802.3dj D3.2

Comment Resolution

Logic Topics

Figure 119-15—Receive state diagram

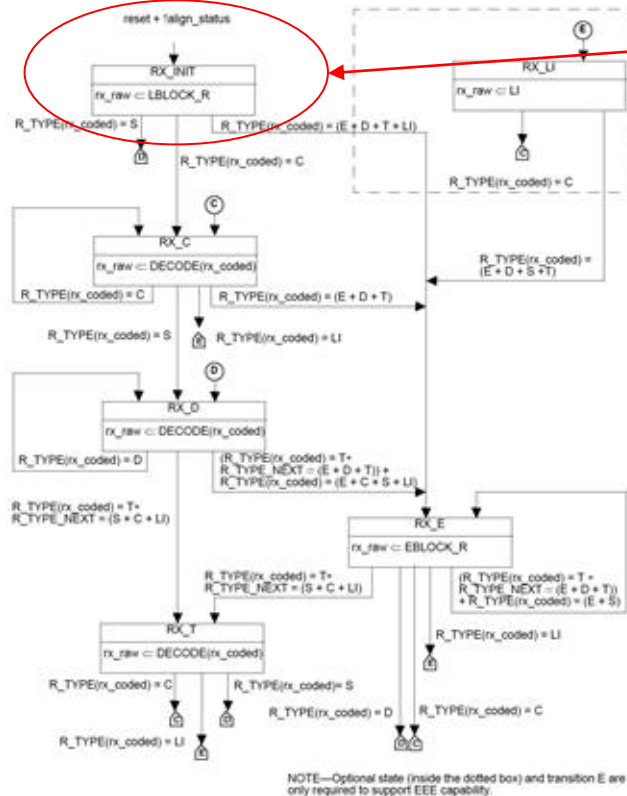
It makes sense that if the PCS has lost alignment marker lock it will generate local faults, as in the case of the state-diagram decoder (see align_status in Figure 119-15).

LBLOCK_R (Local Fault) is used when: (reset or !align_status).

→ Need to add the !align_status condition to also generate Local Fault (LBLOCK_R) to match the state diagram. This is the standard behavior when the PCS cannot decode the incoming signal. (Note: stateless decoder does not check for invalid sequences).

"The stateless decoder generates 200GMII/400GMII transfers based only on the current 66-bit block and the PCS variables align_status and reset (see 119.2.6.2.2). When reset is true or align_status is false, RXD<63:0> and RXC<7:0> are set to the constant LBLOCK_R (see 119.2.6.2.1); otherwise, RXD<63:0> and RXC<7:0> are decoded from rx_coded<65:0> as defined in 119.2.3."
